Title of Change:	NCV68261 - Product robustification
Effective date:	20 Mar 2023
Contact information:	Contact your local onsemi Sales Office or Juraj.Kremmer@onsemi.com
Type of notification:	This Product Bulletin is for notification purposes only. onsemi will proceed with implementation of this change upon publication of this Product Bulletin.
Change Category:	Wafer Fab Change
Change Sub-Category(s):	New masks to increase passivation to pad metal overlap

Representative picture of the passivation to pad metal overlap increase:

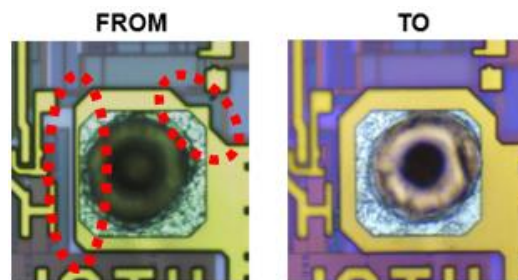
This is a product robustness improvement. In order to make the product more robust against potential issues, the passivation to pad metal overlap has been increased from minimum 2.12 um to minimum 6 um. The change is in the passivation to pad metal overlap only, done by increasing the pad metal dimensions.
No change to the bond pad opening dimensions.
No change in the pad composition and pad metal thickness.

From	To
Minimum passivation to pad metal overlap	2.12um	6um
